INVITATION TO BID 2023-01
CITY OF PARKER
ROADWAY IMPROVEMENTS
PHASE 1

ADDENDUM NO. 1
REQUESTS FOR INFORMATION

Issued July 10, 2023

Sheet No.
C1.2

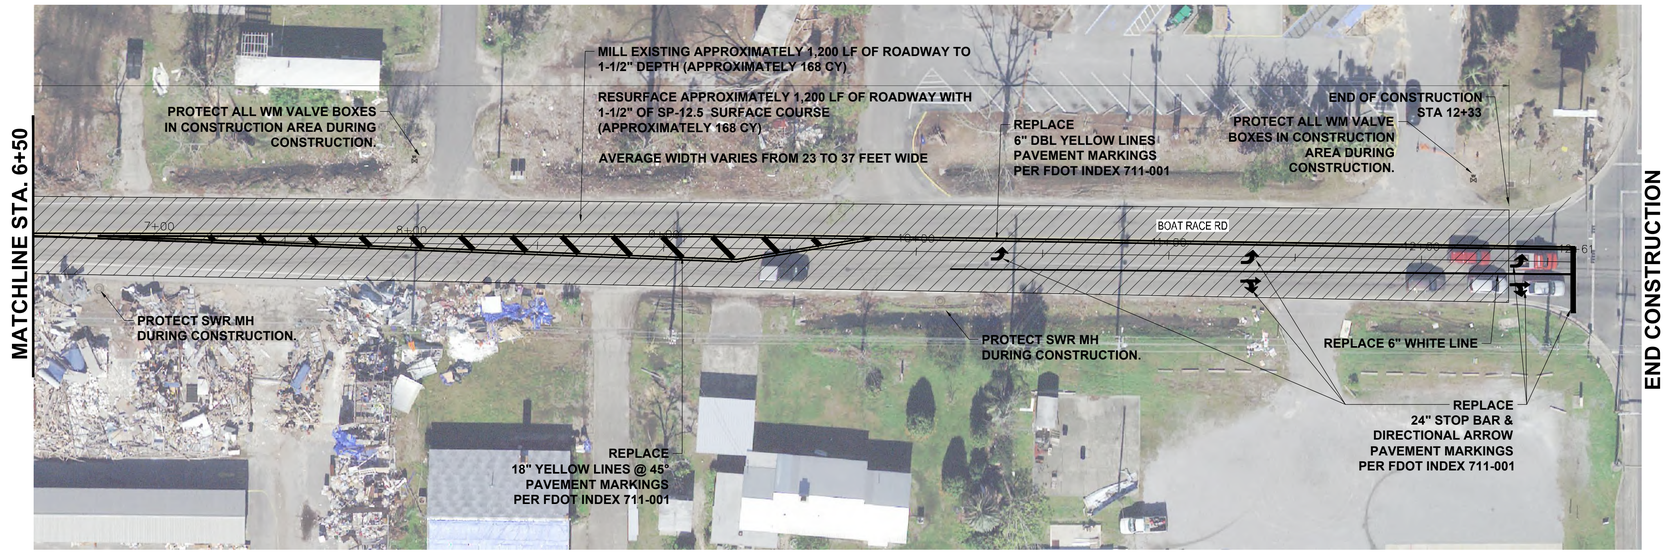
RAI No. 10. Regarding the striping, the plans are showing a 6-inch white strip coming off the 24-inch stop bars, should that be a double-yellow line instead.

City's Response to Request for Information Question No. 10
Yes, please see revised drawings.

Please **REMOVE** the Bid Construction Drawing Set in its entirety and **REPLACE** with the revised Bid Construction Drawing Set which includes modifications to SHEET C1.2 and C1.4 per this comment (refer to ***Attachment B***).

SIDE ROAD TURNOUT DETAIL

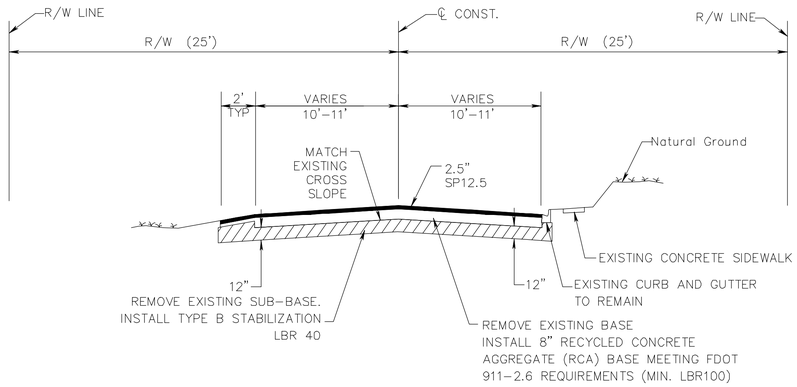
RAI No. 12. On the Side Road Turnout Detail, it's showing 1.0-inch of SP9.5 Friction Course, can we price that as Standard SP9.5 instead?

City's Response to Request for Information Question No. 12
Please provide pricing for SP9.5 Friction Course.

TYPICAL MILLING SECTION

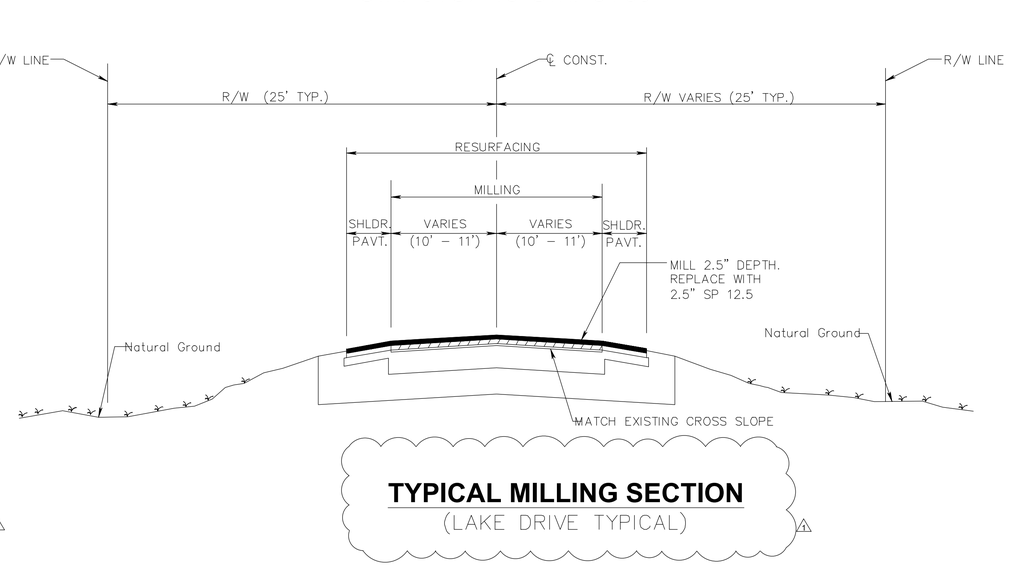
RAI No. 13. On the Typical Milling Section, it's showing to mill and replace with a 2.5-inch layer of asphalt, yet the following roads Lance Drive, Boat Race Road, Thornton Lane and Soule Drive are showing just a 1.5-inch layer to mill and replace. Do we bid the 1.5-inch mill and resurface for Lance Drive, Boat Race Road and Thornton Lane/Soule Drive and 2.5-inch for Lake Drive?

City's Response to Request for Information Question No. 13
Yes. The Typical Milling section for Lake Drive is different from the remaining roadways.

Please **REMOVE** the Bid Construction Drawing Set in its entirety and **REPLACE** with the revised Bid Construction Drawing Set which includes modifications to SHEET C2.2 per this comment (refer to ***Attachment B***).
